# Access Compliance Report

## Public Rights-of-Way

### (Curb Ramps)

Intersection ID: 16042	Main Street: POINDEXTER_DR	Cross Street: SUNSET_DR	Location:	E
ADA ID: 49D581C64F6A	Ramp Type: Combination1Diag	Initial Pass/Fail: Fail	Overall Compliance: No	Severity Score: 0

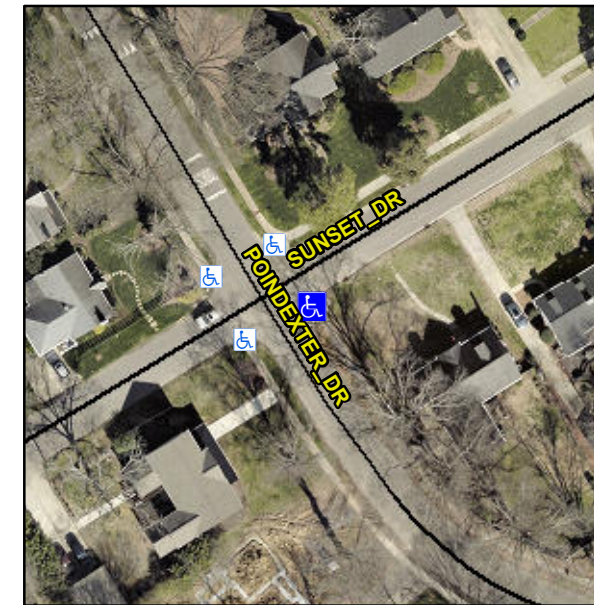
**Not Found, R304.5.1, R304.5.3**

Compliance	Description	Data	Compliance	Description	Data
N/A	Ramp Length LT (in)	49.0	N/A	Ramp Length RT (in)	21.0
No	Ramp Width LT (in)	33.0	No	Ramp Width RT (in)	43.0
Yes	Ramp Slope LT (%)	6.1	Yes	Ramp Slope RT (%)	5.9
No	Ramp XSlope LT (%)	4.2	No	Ramp XSlope RT (%)	2.1
N/A	Ramp Length (in)	40.0	Yes	Ramp Slope (%)	6.1
Yes	Ramp Width (in)	48.0	Yes	Ramp XSlope (%)	1.5
N/A	Flare Type LT	N/A	N/A	Flare Type RT	N/A
N/A	Flare Slope LT (%)	N/A	N/A	Flare Slope RT (%)	N/A
N/A	Flare Traversable LT?	N/A	N/A	Flare Traversable RT?	N/A
N/A	Landing Length (in)	N/A	N/A	DWS Provided?	N/A
N/A	Landing Width (in)	N/A	N/A	DWS Contrast?	N/A
N/A	Landing Slope (%)	N/A	N/A	DWS Length (in)	N/A
N/A	Landing X Slope (%)	N/A	N/A	DWS Full Width?	N/A
N/A	Landing Curb? (Y/N)	N/A	N/A	DWS Offset (in)	N/A
N/A	Shared Landing?	N/A			
N/A	Gutter Ponding?	N/A	N/A	Gutter Slope (%)	N/A
N/A	Gutter Lip Ht (in)	N/A	N/A	Gutter X Slope (%)	N/A
N/A	Painted X Walk1?	No	N/A	Painted X Walk2?	No

**Remove & Replace Curb Ramp With Two New Directional Ramps or Equivalent.**
